RE: **PETITION NO. 1497A** - Bloom Energy Corporation amended petition for a declaratory ruling, pursuant to Connecticut General Statutes §4-176 and §16-50k, for the proposed construction, maintenance and operation of a customer-side 2-megawatt fuel cell facility and associated

Petition No. 1497A  
Bloom Energy Corporation  
Bridgeport Hospital  
267 Grant Street, Bridgeport

Interrogatories  
May 16, 2023

**Attachment 1: Sound Barrier Site Plan Detail**

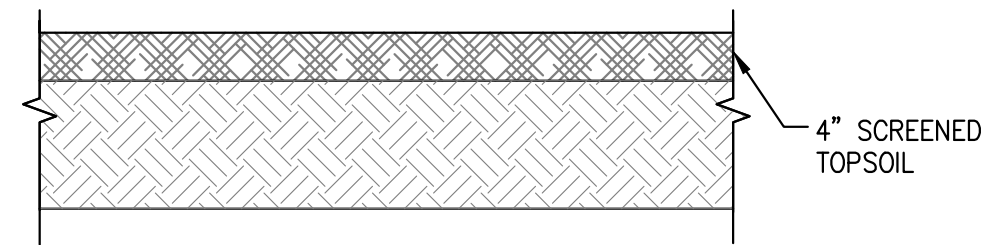
b. Provide a photograph of a similar sound barrier of the same proposed materials, if available.

**Response: Please see below example photos from the Acoustiblok website for reference.**

**CHAIN LINK FENCE AND GATE DETAIL**

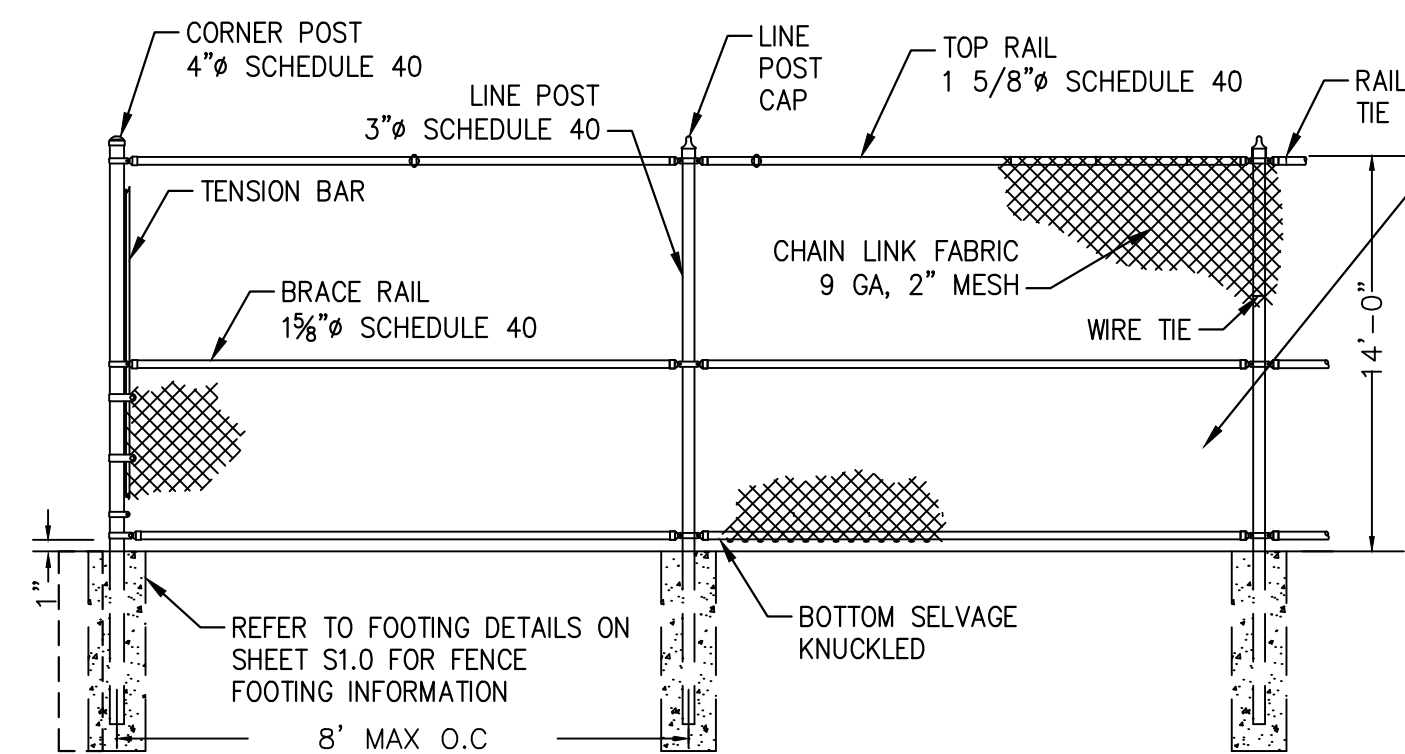
c. Provide construction detail of the proposed sound barrier.

**Response: Please see attached sheet C3.1, detail 4 for fence detail and sheet S1.0 for fence footing details. Because the sound barrier is a material that hangs on the fence, there is no construction detail associated with the sound barrier itself.**

- NOTES:**
- CONTRACTOR SHALL INSTALL ACOUSTIBLOK AF8H-F8XL ACOUSTIFENCE VERTICAL CURTAINS TO CHAIN LINK FENCE USING 250LB STAINLESS STEEL CABLE TIES. SOUND FABRIC SHALL BE INSTALLED PER MANUFACTURER SPECIFICATIONS AND ALONG THE ENERGY SERVER SIDE OF FENCE.
  - ALL FENCE MATERIALS SHALL BE GALVANIZED. REVIEW PRIOR TO FABRICATION.
  - FOR DOUBLE GATES USE SAME CONNECTION FOR EACH GATE.
  - CONTRACTOR SHALL PROVIDE SHOP DRAWINGS AND CALCULATIONS FOR FENCE POSTS, RAILINGS, GATE, AND HARDWARE TO EOR FOR REVIEW PRIOR TO FABRICATION.
